Access Compliance Report

Public Rights-of-Way

(Curb Ramps)

Intersection ID: 15291	Main Street: OLD_MEADOW_RD	Cross Street: SPRINGBEAUTY_DR	Location: NE
ADA ID: 838CB377C2F5	Ramp Type: PerpDiag	Initial Pass/Fail: Fail	Overall Compliance: No
		Severity Score: 25

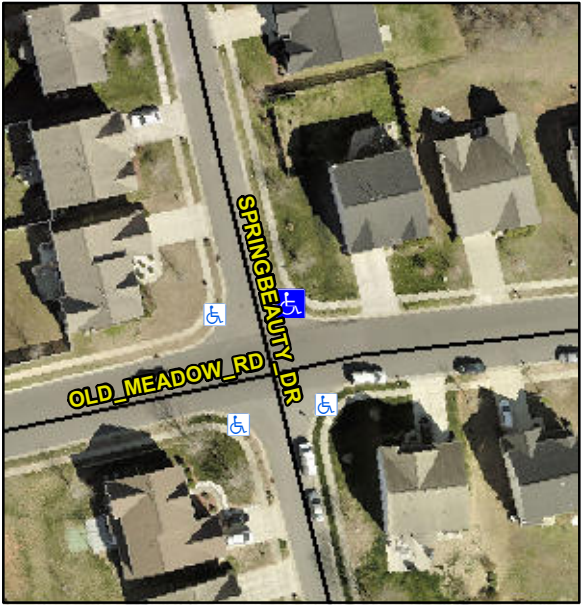
Codes/Mitigation Info/Possible Solution			Field Measurements/Component Compliance		
	Possible Solutions:		Compliance	Description	Data
	Remove & Replace Curb Ramp With Two New Directional Ramps or Equivalent.		N/A	Ramp Length (in)	48.0
			Yes	Ramp Width (in)	48.0
			N/A	Flare Type LT	N/A
			N/A	Flare Slope LT (%)	N/A
			N/A	Flare Traversable LT?	N/A
			N/A	Landing Length (in)	N/A
			N/A	Landing Width (in)	N/A
			N/A	Landing Slope (%)	N/A
			N/A	Landing X Slope (%)	N/A
<p>Surveyor Notes:</p> <p>N/A</p> <p>PROW/ADA:</p> <p>R304.2.2, R304.5.3</p>			N/A	Flare Type RT	N/A
			N/A	Flare Slope RT (%)	N/A
			N/A	Flare Traversable RT?	N/A
			N/A	DWS Provided?	N/A
			N/A	DWS Contrast?	N/A
			N/A	DWS Length (in)	N/A
			N/A	DWS Full Width?	N/A
			N/A	DWS Offset (in)	N/A
			N/A	Gutter Ponding?	N/A
			N/A	Gutter Lip Ht (in)	N/A
			N/A	Painted X Walk1?	No
				X Walk 1 Direction	To S
			N/A	X Walk 1 Width (in)	N/A
				X Walk 1 Slope (%)	4.6

X Walk 1 X Slope (%)	3.3
			N/A	Ramp inside XWalk1?	N/A
				Road Slope (%)	4.4
				Road X Slope (%)	0.8
			N/A	Any Obstructions?	N/A
				Obstruction Type	
Total Cost:		\$ 3200.00			
			N/A		N/A
			Yes	Surface Condition? (G/P)	Good
